Denial

Subject: Mine Ventilation Plan, Section 75.370, 30 CFR 75, Upper  
Big Branch Mine - South, I.D. No. 46-08436, Performance  
Coal Company, Montcoal, Raleigh County, West Virginia

This will acknowledge receipt of a revision to the ventilation plan, submitted to this office and dated March 5, 2010. This revision requests to install and remove ventilation controls for the purpose of mining Track Mains (MMU-042) off of LBB 2 #4 Mains.

Re: Performance Coal Company  
Upper Big Branch Mine  
MSHA ID: 46-08436  
State ID: U-3042-92  
Ventilation Revision

<b>PERFORMANCE COAL COMPANY</b> P.O. BOX 62, NIXON, WV 26110	
	<b>UPPER BIG BRANCH MINE</b>	
MSHA ID No. 48-08135	WV ID No. U5542-92	
03-04-12	SCALE: 1"=200'	03/05 No. 1 of 1
DRAWN BY: PL 3 SMT	CHECKED BY:	
<b>ADDITIONAL INTAKES AT EUNICE PORTAL</b>		
<b>VENTILATION REVISION</b>

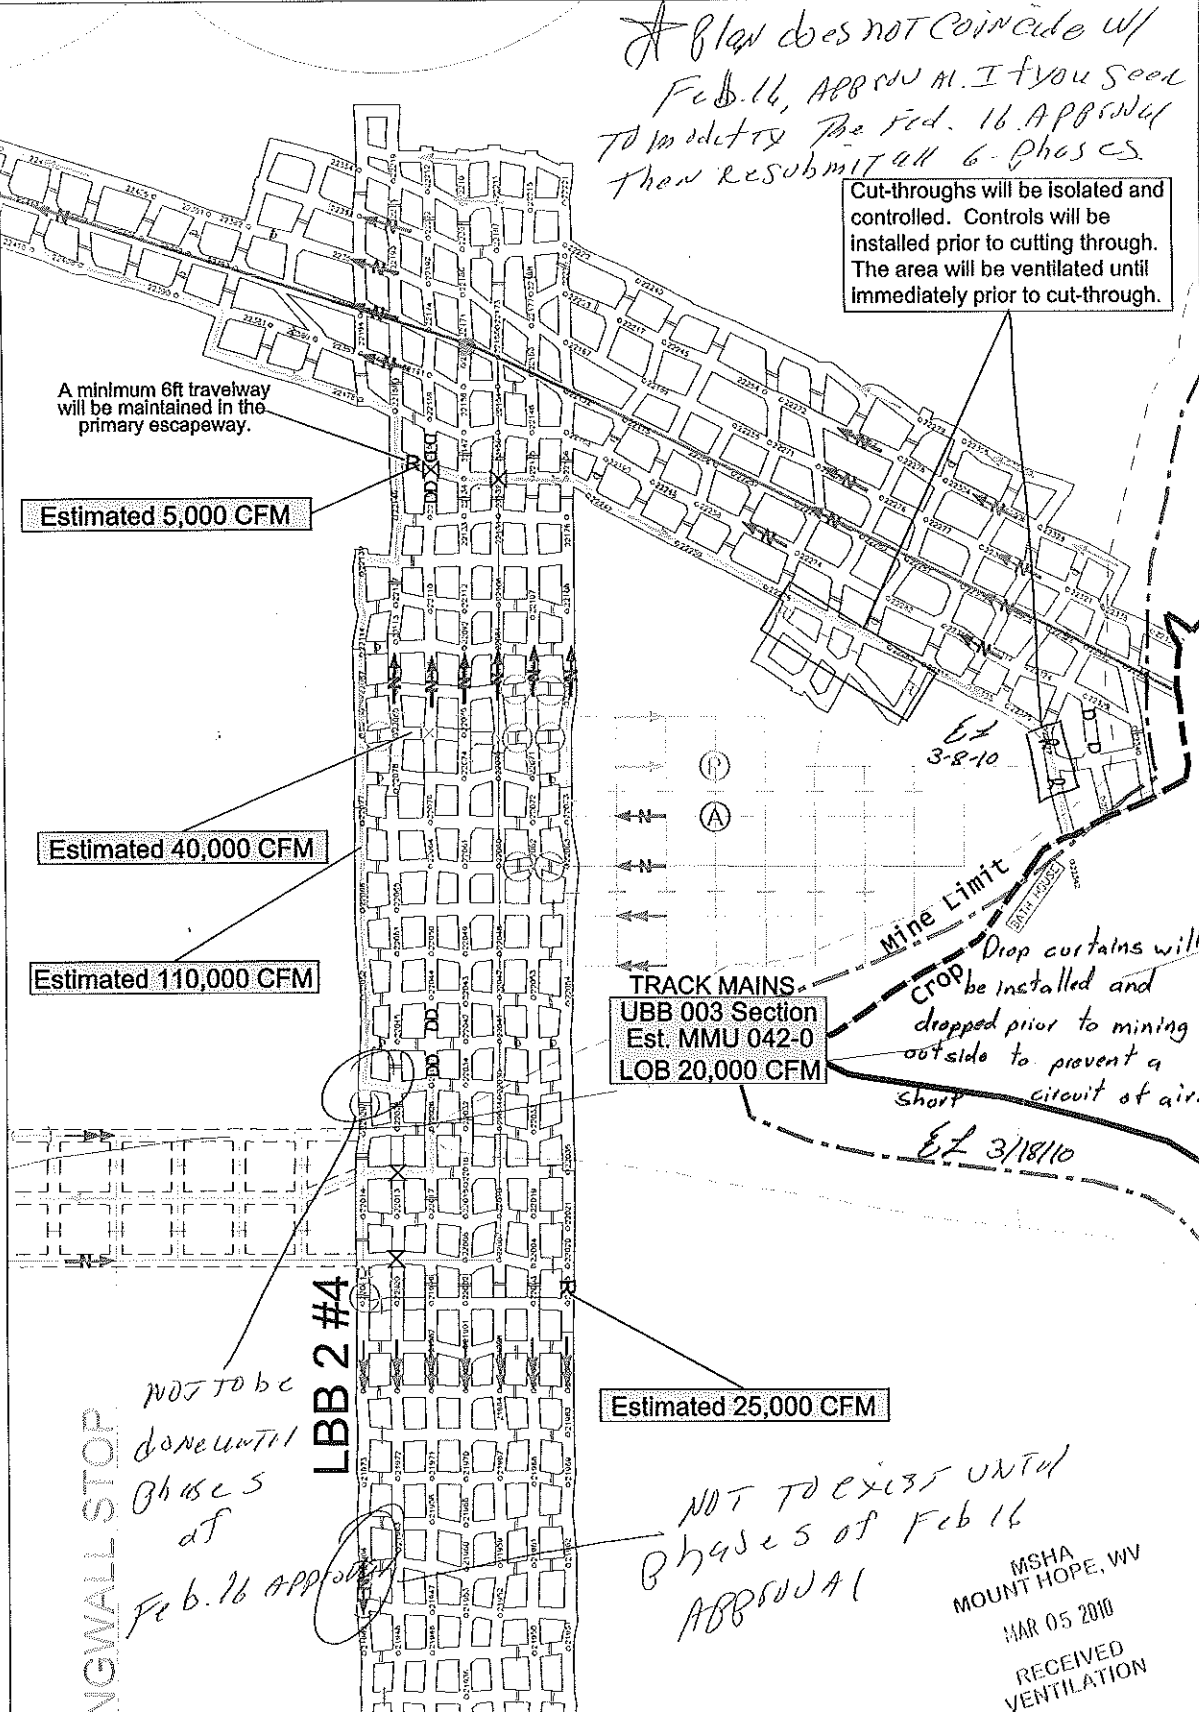
This revision does not follow the previous 6-phase revision which was approved on February 16, 2010. The neutral aircourse shown on the submitted maps is not to exist until the approved Phase 5, and the return aircourse for the headgate develop section appears to mix with the intake. Because this revision does not coincide with the previously approved revision, this revision cannot be approved. If you seek to modify the February 16, 2010 revision, then please resubmit all 6 phases to reflect the changes contained within this revision.

*\* Plan does not coincide w/ Feb. 16, APPROVAL. If you seek to modify the Feb. 16 APPROVAL then resubmit all 6-phases.*

*NOT TO BE DONE UNTIL PHASES OF Feb. 16 APPROVAL*

*NOT TO EXIST UNTIL PHASES OF Feb 16 APPROVAL*
